Pacific Gas and
Electric Company

6/15/10 Board Meeting
2010 Integrated Report 303(d)
Deadline: 5/28/10 by 12 noon

RE: PG&E's Comment Letter – 2010 Integrated Report / Section 303(d) List

Figure A-1. Water Segment Delineation for the North Fork Feather River between Lake Almanor and Lake Oroville

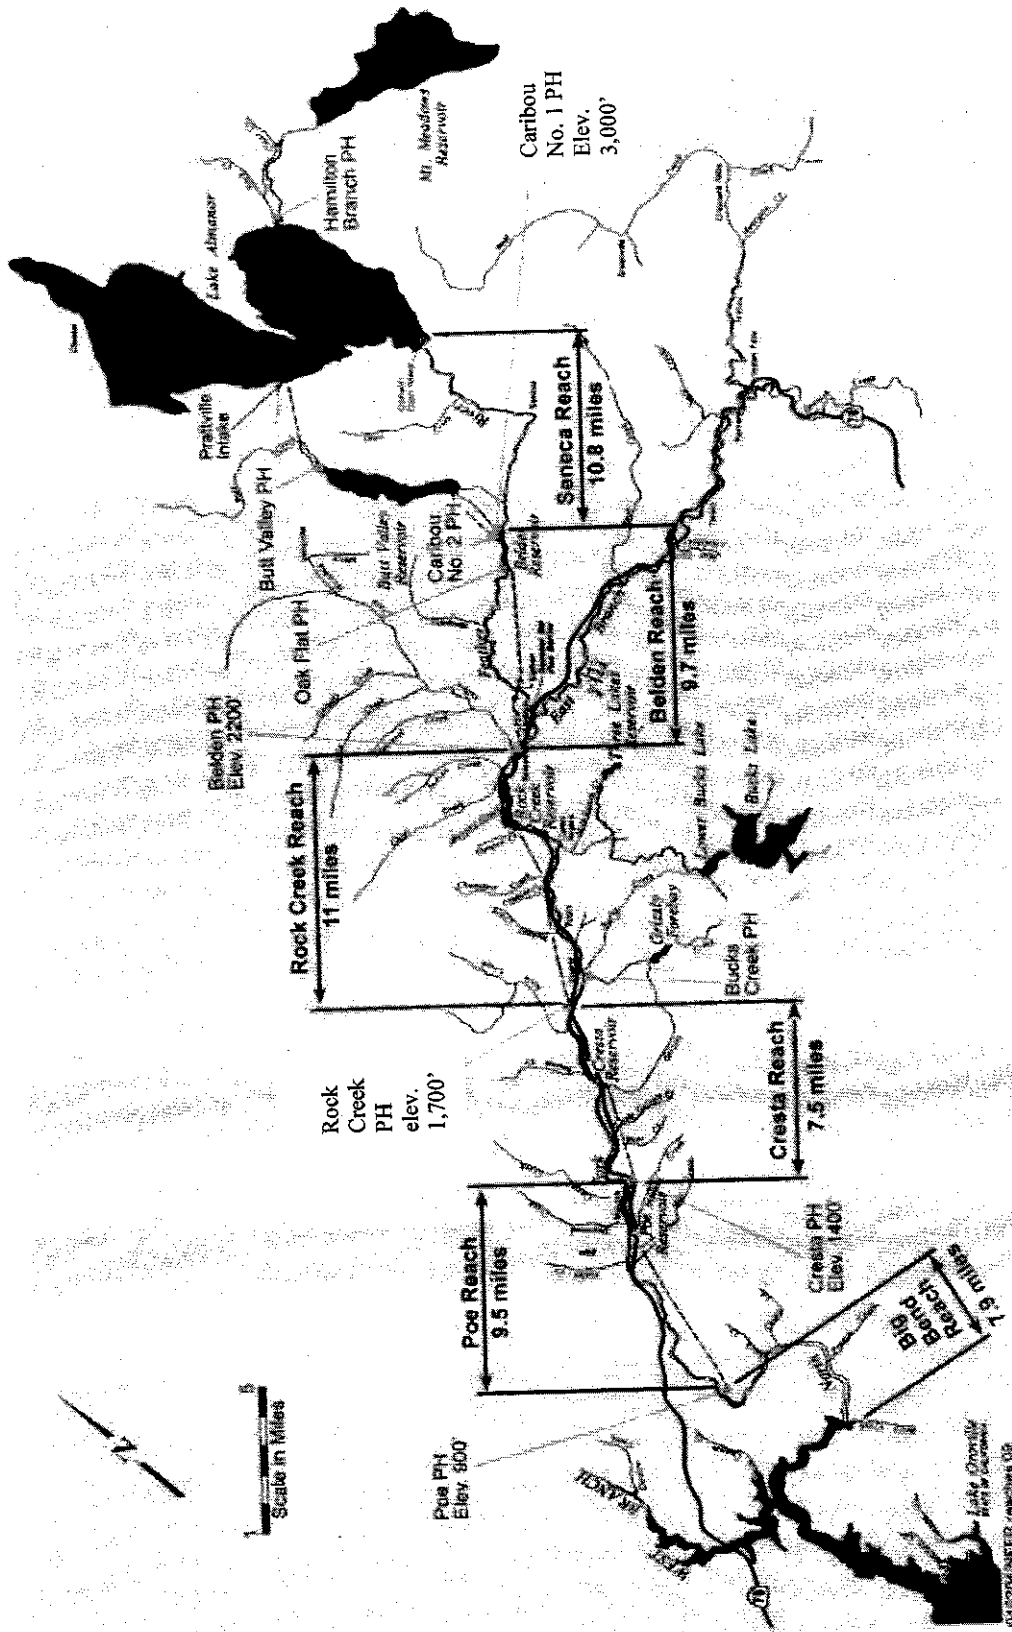
PG&E recommends that the CBRWQCB break the North Fork Feather River (NFFR) listings for water temperature, mercury, unknown toxicity, PCBs, and any other future determinations of health or impairment into separate water segments based upon knowledge of factors such as elevation, flow, channel morphology, substrate, riparian condition, adjoining land uses, confluence with other waterbodies, and potential sources of pollutant loadings as suggested in Figure A-1. The CVRWQCB should then review the known available data for each individual water segment to determine whether listing or delisting is appropriate for that specific water segment only based upon known available data or other evidence from that specific water segment or river reach.

Six water segments are proposed for the NFFR between Lake Almanor and Lake Oroville and include Seneca Reach, Belden Reach, Rock Creek Reach, Cresta Reach, Poe Reach, and Big Bend Reach (Figure A-1). PG&E has provided individual factsheets for each water segment for the water temperature, mercury, unknown toxicity, and PCB listings for the NFFR and the factsheets include PG&E's recommendations for each water segment based upon the known available data for the specific water segments (river reaches).

Figure A-2. Water Segment Delineation of the South Yuba River below Lake Spaulding to Englebright Reservoir.

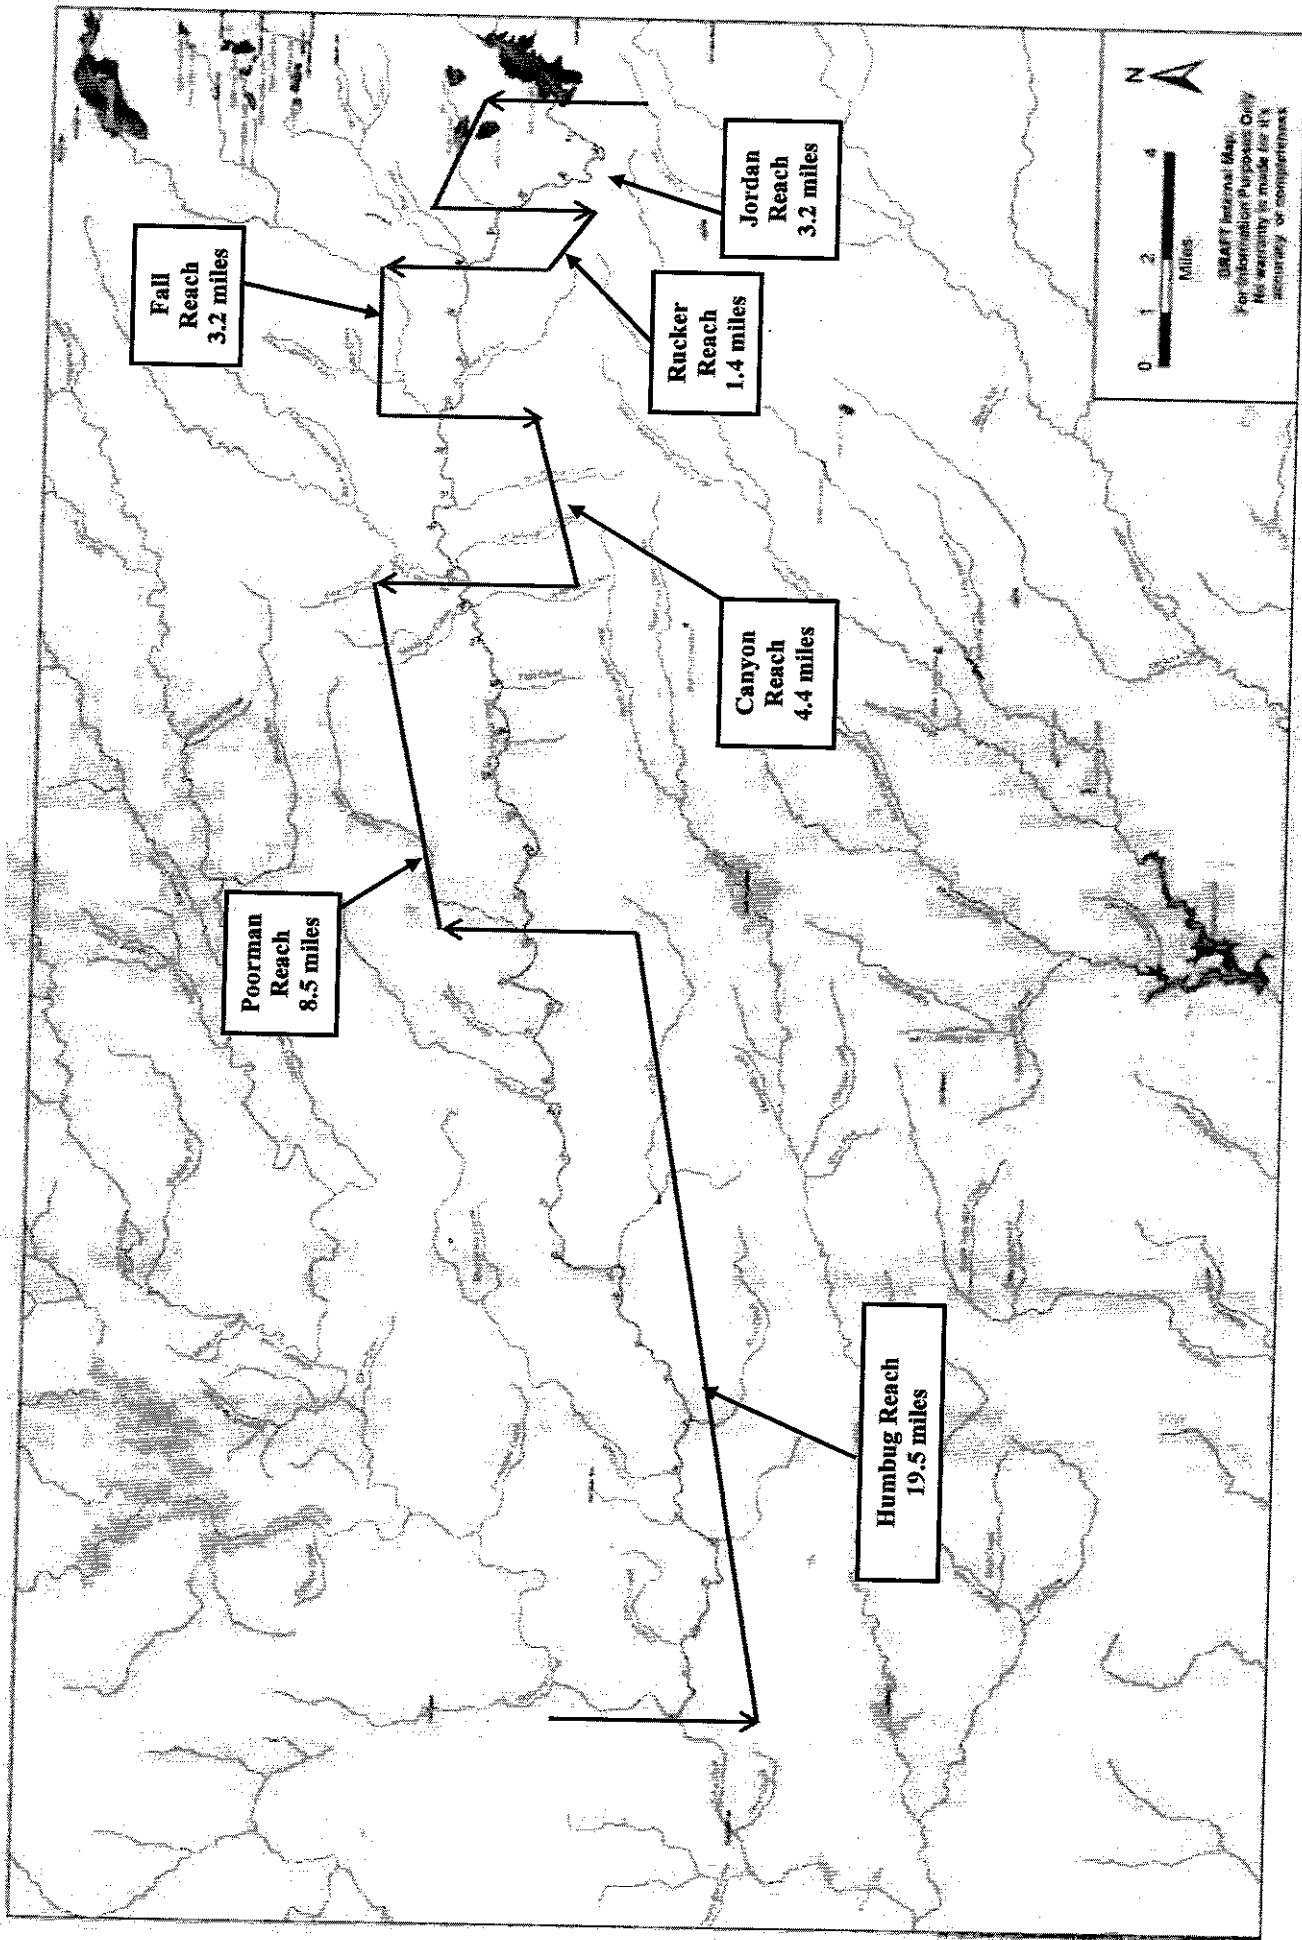
PG&E also recommends that the CVRWQCB break the South Yuba River (from Lake Spaulding to Englebright Reservoir) listings for water

temperature and mercury, and any other future determinations of health or impairment into separate water segments based upon knowledge of factors such as elevation, flow, channel morphology, substrate, riparian condition, adjoining land uses, confluence with other waterbodies, and potential sources of pollutant loadings as suggested in Figure A-2. The CVRWQCB should then review the known available data for each individual water segment to determine whether listing or delisting is appropriate for that specific water segment only based upon known available data or other evidence from that specific water segment or river reach.

Six water segments are proposed for the South Yuba River between Lake Spaulding and Englebright Reservoir and include Jordan Reach, Rucker Reach, Fall Reach, Canyon Reach, Poorman Reach, and Humbug Reach (Figure A-2). PG&E has provided individual factsheets for each water segment for the water temperature and mercury listings for the South Yuba River and the factsheets include PG&E's recommendations for each water segment based upon the known available data for the specific water segments (river reaches).

Figure F-1. Water Segment Delineation for the North Fork Feather River for Water Temperature Assessment

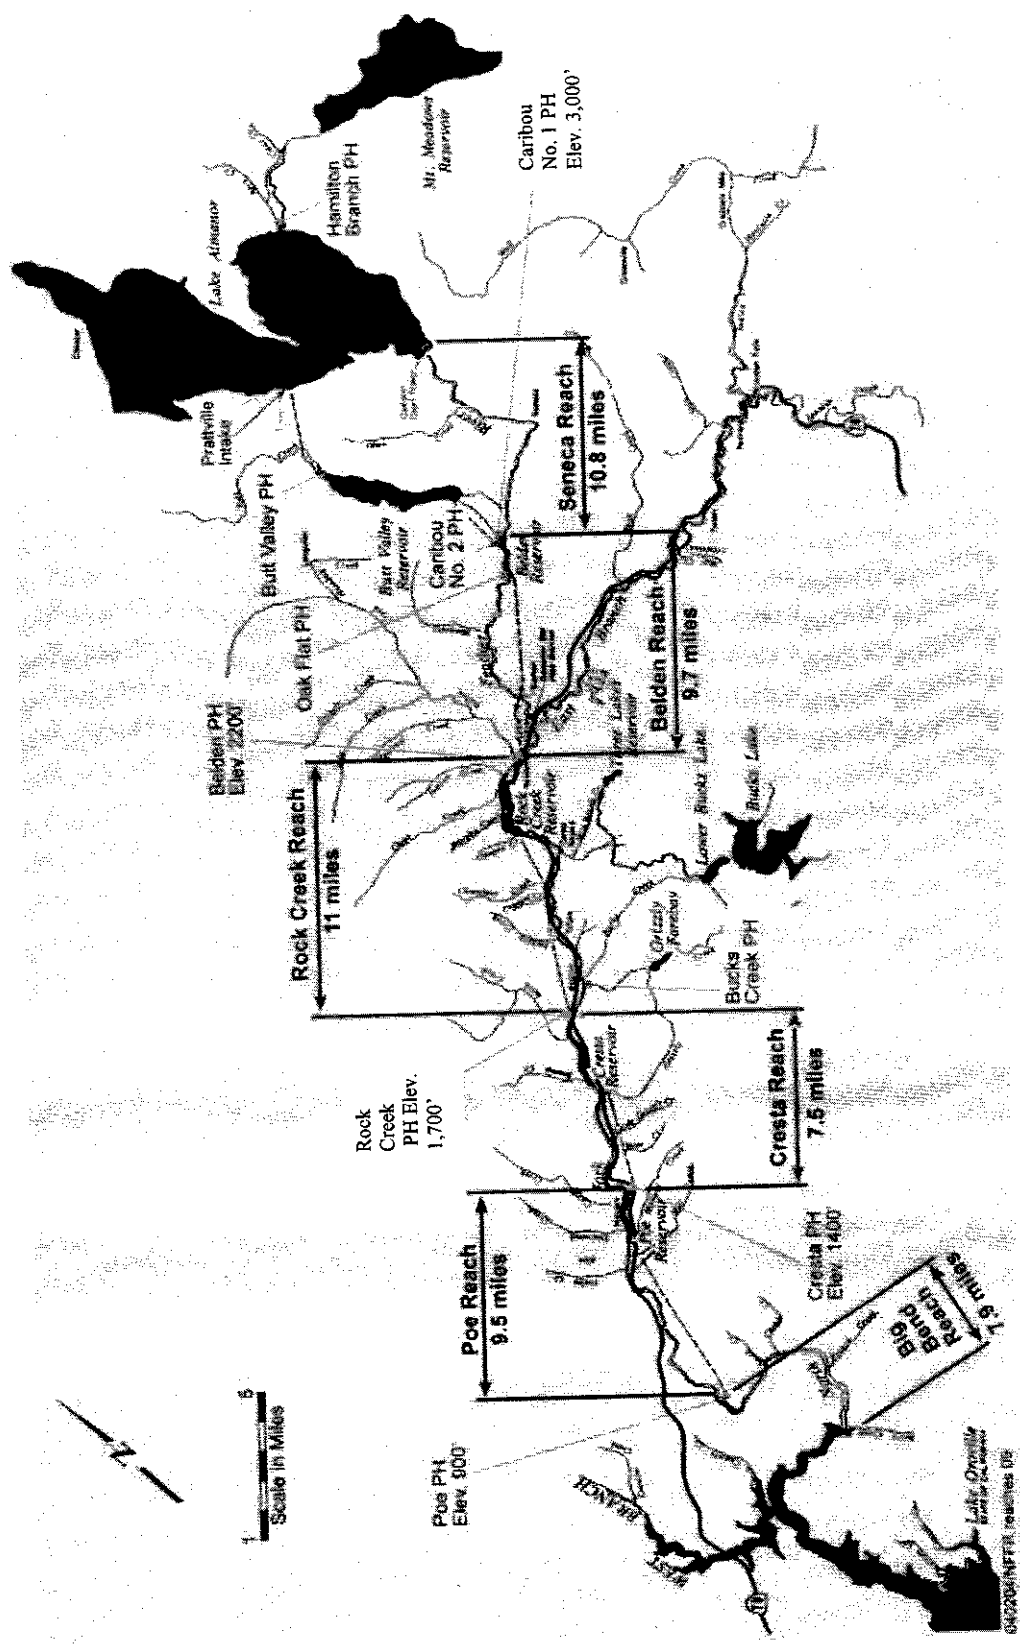
WATER SEGMENT:	North Fork Feather River below Lake Almanor to Lake Oroville (The proposed 2008 listing included the entire 56+ mile stretch – without any segmentation)
POLLUTANT:	Water temperature
SOURCE:	Flow Regulation/Modification Hydromodification
STATUS of Proposed 2008 303(d) LISTING:	Listed
CVRWQCB STAFF BASIS:	After review of the available data and information, Central Valley Regional Water Quality Control Board (CVRWQCB) staff concluded that the water body-pollutant combination should be placed on the section 303(d) list because applicable water quality standards were exceeded and a pollutant contributes to or causes the problem.
PG&E's RECOMMENDATION:	Address potential for listing by water segment delineation and Do Not List based upon available data for each water segment.
PG&E's COMMENTS:	<p>The CVRWQCB listed the entire North Fork Feather River (NFFR) from the Seneca Reach through the Big Bend Reach due to exceedances of water temperature guidelines found in Sullivan et. al. (2000) and various reports on fish population/community degradation, as interpreted from the data reported in Wales et. al (1952), Rowely (1955), Gerstung (1973), and Wixom (1989), along with other anecdotal information (historical photos). Arguments provided in the Water Segment Delineation Factsheet (Attachment A) explain the necessity for determining appropriateness of listing or Do Not List by defined river segments based upon environmental, biological, and physical differences. PG&E believes that the TMDL process will be more reflective of current conditions and truly impaired water segments may be addressed more efficiently if water segment delineation were followed when determining the list of 303(d) impaired waters.</p> <p>First, the Feather River changes substantially as it moves from its headwaters into the Sacramento Valley due to changes in elevation (from over 4,500 ft to 900 ft), gradient (from ≥ 140 ft/mile to ≤ 45 ft/mile), climate (up to a summer time average diurnal difference of 10°F), and river flow (average of less than 35 cfs to more than 250 cfs between sections). Thus, the Feather River should be evaluated by segment and below we have outlined the specific segments</p>

and the data correlated with each segment. Factsheets for each reach of the NFFR (Seneca, Belden, Rock Creek, Cresta, Poe, and Big Bend) are provided in this submission and include information regarding the health of each river segment based upon the most recent readily available data from the specific water segments (see Figure F-1).

Figure F-2. Historical and Current Trout Composition Percentage for Belden Reach .

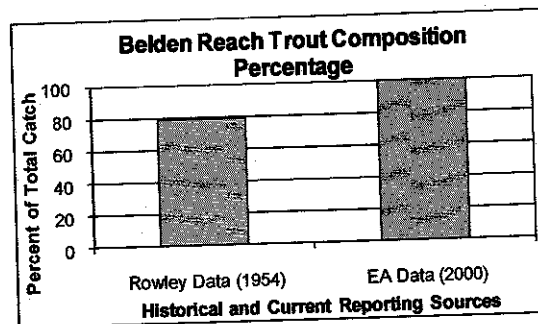
Angler surveys conducted in this reach in 2000 by EA Engineering, Science, and Technology (2001) reported a catch rate of 0.66 trout per hour, in which 100% of all fish caught were rainbow trout, and that 20% of the trout caught were equal to or greater than 11 inches long (Figure F-2. In general, these were all greater than the data reported by Rowely (1955), and are shown in Table F-1 and in Figure F-2 below.

While there are some exceedances of the Sullivan and US EPA guidelines in this reach, the available current data show that water temperature alone is not a good measure of the health of water segments as displayed by the healthy

Figure F-3. Number of rainbow trout caught per hour by study year for Rock Creek Reach

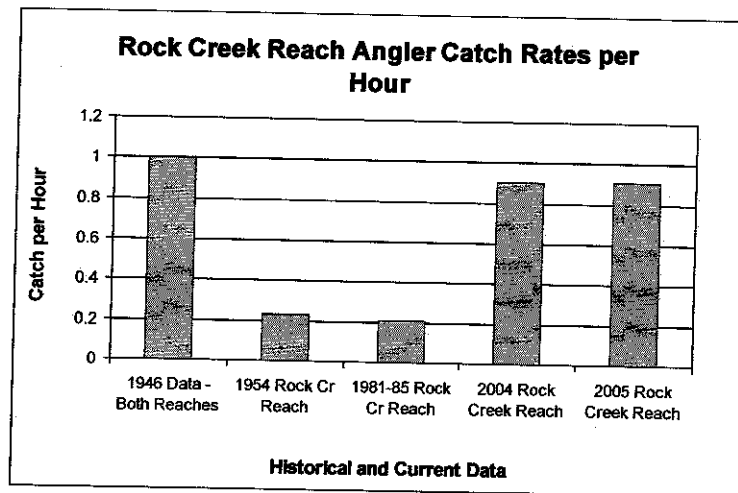
Angler surveys conducted in this reach in 2005 reported that 74% of all fish caught were rainbow trout, with an average length of 12.3 inches and with almost 7% of them being equal to or greater than 17 inches long. Angler catch per hour in 2004, and 2005 for the riverine portion of the Rock Creek reach was 0.90 and 0.91 trout/hour, respectively, which is very close to the 1 fish/hour reported for the pre-project period (1946) by Wixom (1989). Table F-2 and Figure F-3, below, compare all of the trout/hour data presented in the original listing along with the most recent data from 2004 and 2005. Based on the relatively high composition percentage of rainbow trout reported in the angler surveys and success rate (catch /hour), this stream reach should be considered biologically healthy regardless of the periodic water temperature exceedances of the Sullivan guideline.

The available current data show that water temperature alone is not a good measure of the health of water segments as displayed by the healthy fish populations and catch per hour of rainbow trout in 2004 and 2005 being nearly equal to the highest historical value listed for 1946 for the Rock Creek Reach. While there are some exceedances of the Sullivan guideline in this reach there are very few if any exceedances of the US EPA guideline. In addition, the elevation and climatic influences on the waters in this reach are greater compared to the waters originating at Canyon Dam approximately 20.5 miles upstream and at an elevation approximately 2,800 ft greater than at this end of this reach (at the Rock Creek Powerhouse). Therefore, this water segment should be removed from the 303(d) list of impaired water bodies.

Figure F-4. Number of rainbow trout caught per hour by study year for Cresta Reach.

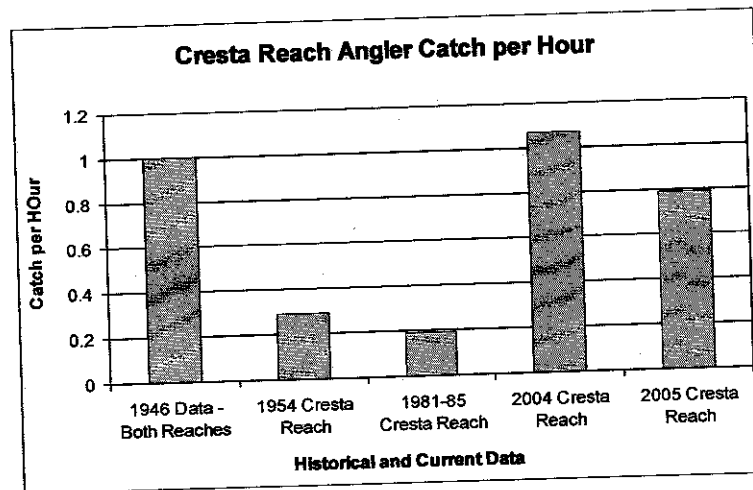
Angler surveys conducted in these reaches in 2005 reported that 74% of all fish caught were rainbow trout, with an average length of 12.3 inches and with almost 7% of them being equal to or greater than 17 inches long. Angler catch per hour in 2004 and 2005 for the riverine portion of the Cresta reach was 1.07 and 0.79 trout/hour, respectively, equal to the 1 fish/hour reported for the pre-project period (1946) by Wixom (1989) in 2004 and very close to it in 2005. Figure F-4 and Table F-3 below compares all of the trout/hour data presented in the original listing along with the most recent data from 2004 and 2005. Based on the relatively high percentage of rainbow trout reported in the angler surveys and success rate (catch /hour), this stream reach should be considered biologically healthy regardless of the periodic water temperature exceedances of the Sullivan guideline.

The available current data show that water temperature alone is not a good measure of the health of water segments as displayed by the healthy fish populations and catch per hour of rainbow trout in 2004 and 2005 exceeding or nearly equal to the highest historical value listed for 1946 for the Cresta Reach. While there are some exceedances of the Sullivan guideline in this reach there are very few if any exceedances of the US EPA guideline. In addition, the elevation and climatic influences on the waters in this reach are greater compared the waters originating at Canyon Dam approximately 31.5 miles upstream and at an elevation approximately 3,100 ft greater than at the end of this reach . Therefore, this water segment should be removed from the 303(d) list of impaired water bodies.
